REVISION: OVERSIGHT CONCERN - DATED FEBRUARY 23RD, 2022
SHEETS: A102, A103, A105, A200, A201, A203, A204, A300, A4.03

NO.	DESCRIPTION	DATE
1	REVISED AS PER CITY COMMENTS - DP	2021-10-27
2	OVERSIGHT COMMENTS	2022-02-23

364 E 14TH STREET
DUPLEX INFILL
COVER SHEET

1 MAIN FLOOR PLAN - EXISTING HERITAGE HOUSE & PROPOSED DUPLEX
1/4" = 1'-0"

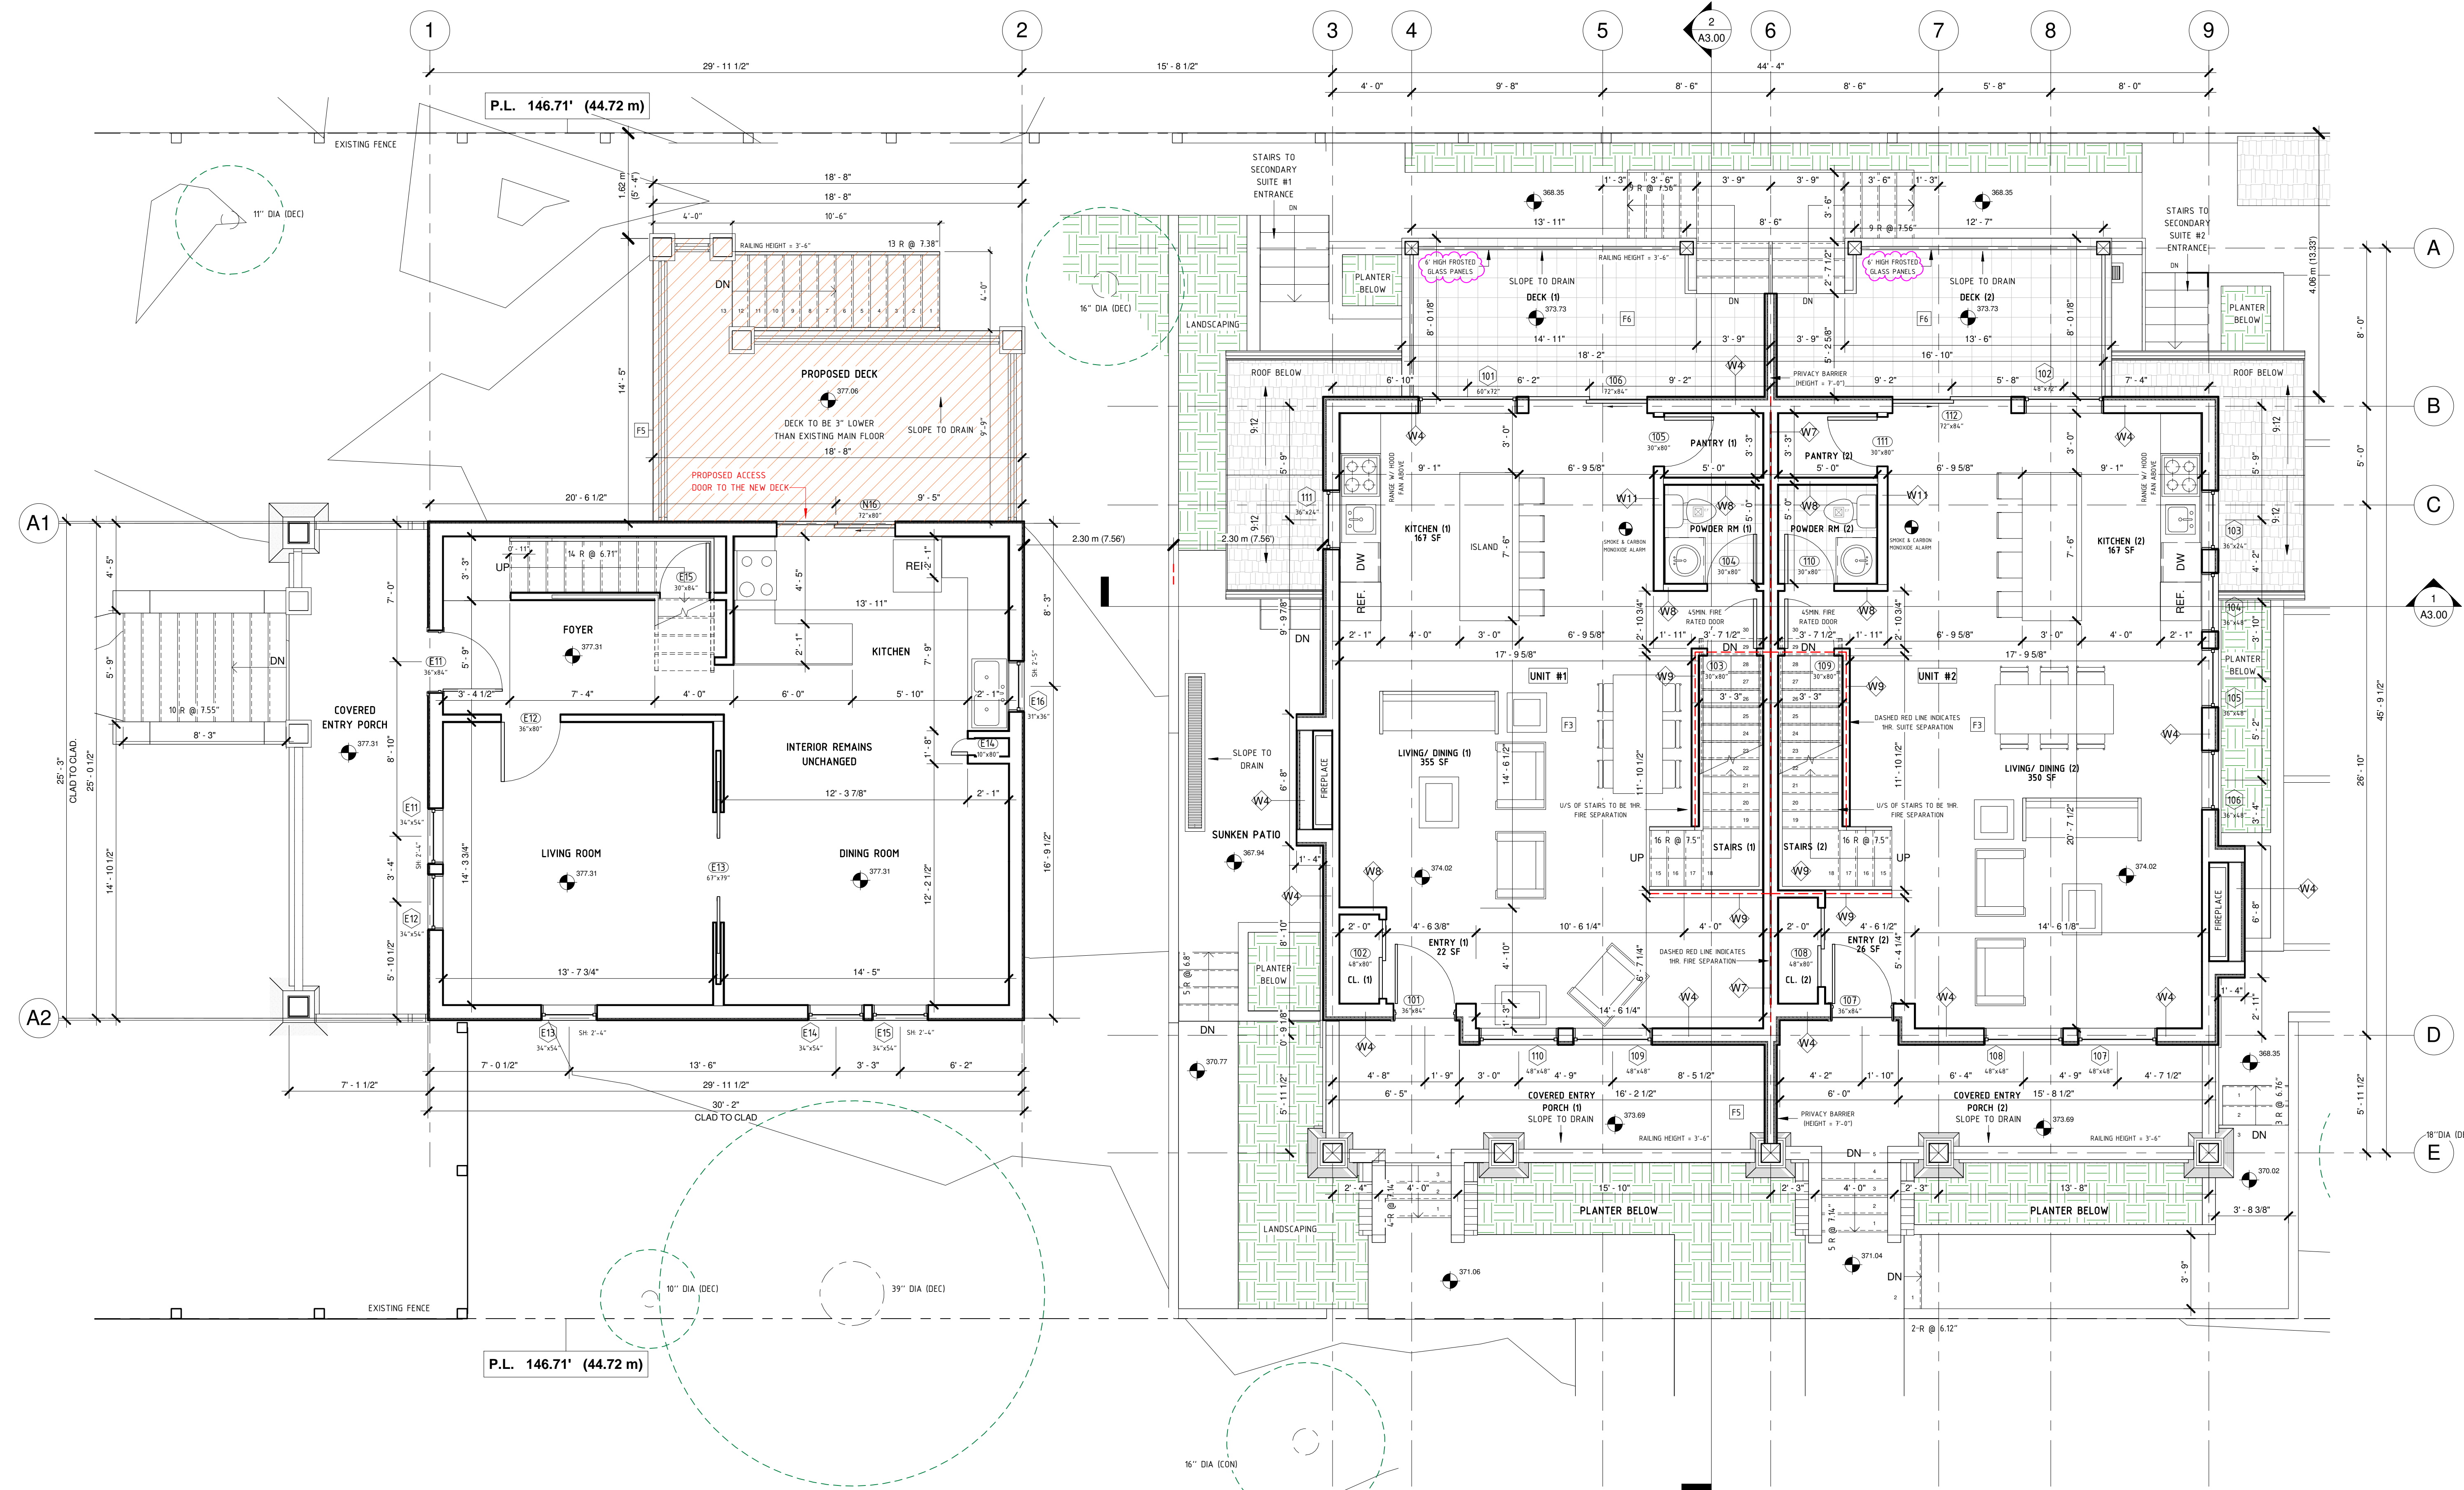
REVISION:
11 6" HIGH FROSTED GLASS PANELS ADDED ALONG THE FACE OF THE WEST DECKS TO CREATE MORE PRIVACY BOTH WAYS

1 UPPER FLOOR PLAN - EXISTING HERITAGE HOUSE & PROPOSED DUPLEX
1/4" = 1'-0"

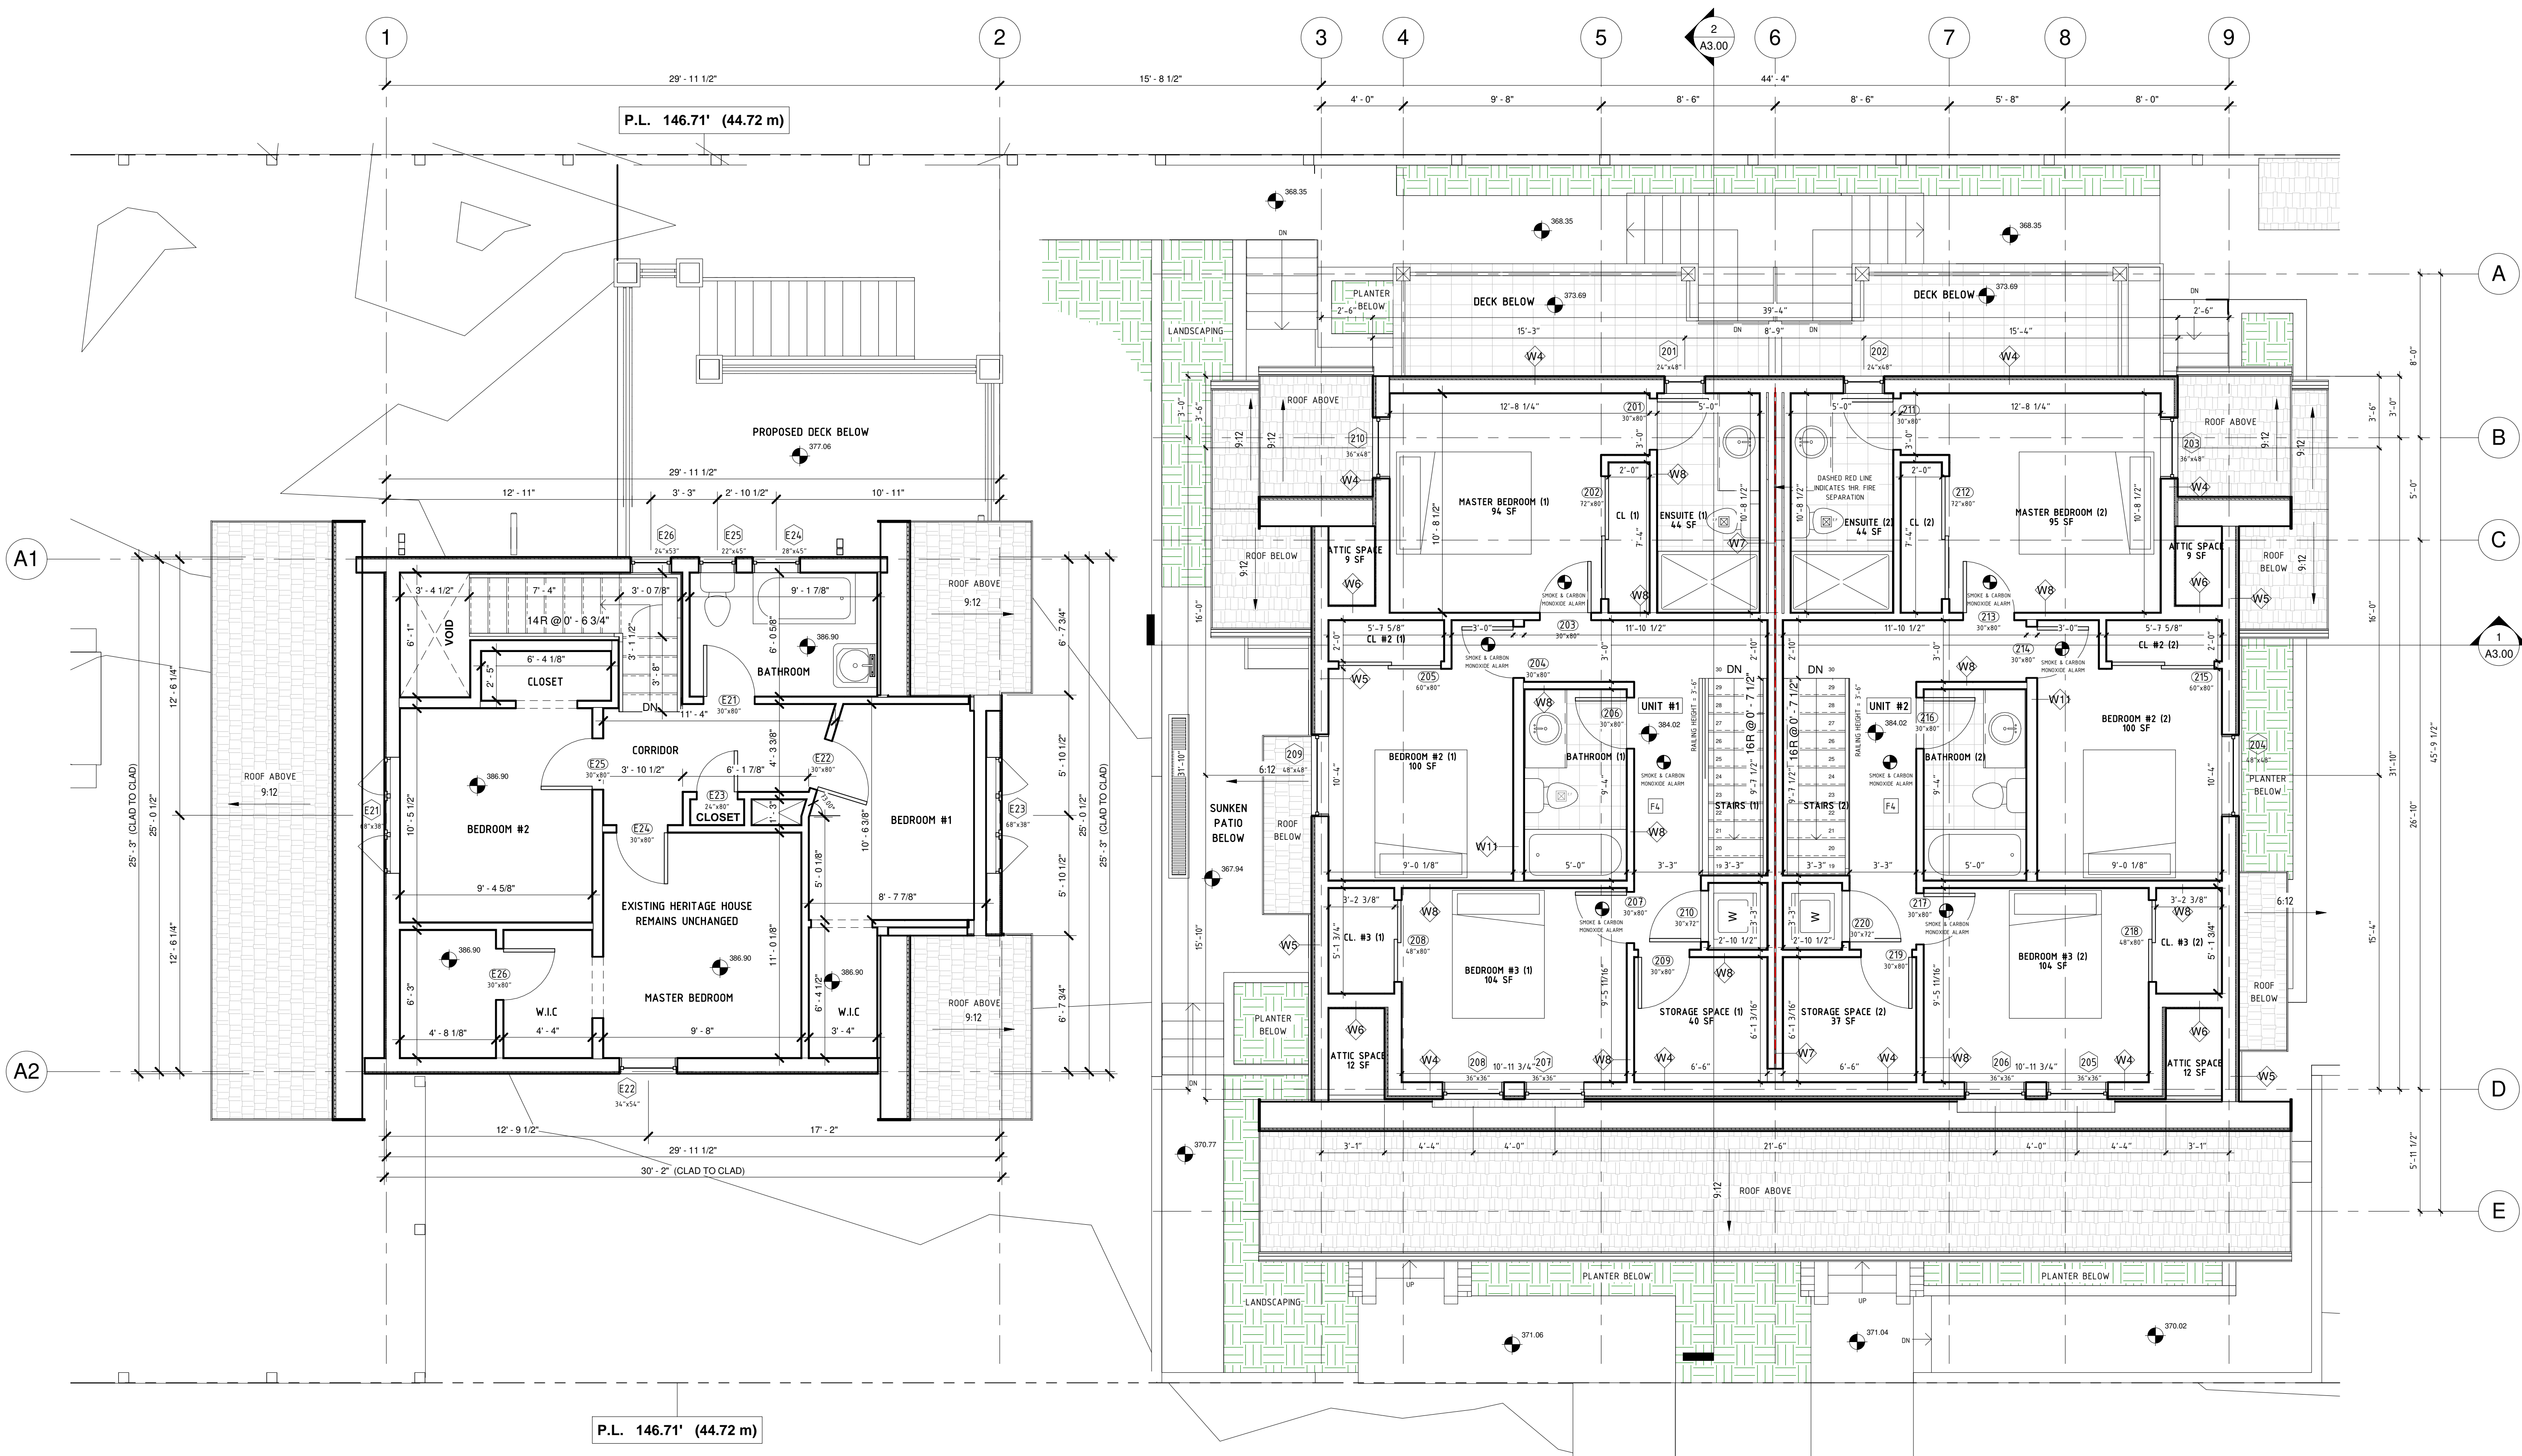
REVISION:
1) REDESIGN OF THE UPPER FLOOR TO PUT THE BEDROOM WINDOWS FACING NORTH AND SOUTH INSTEAD OF WEST
2) BATHROOM WINDOWS FACING WEST TO BE FROSTED GLASS.
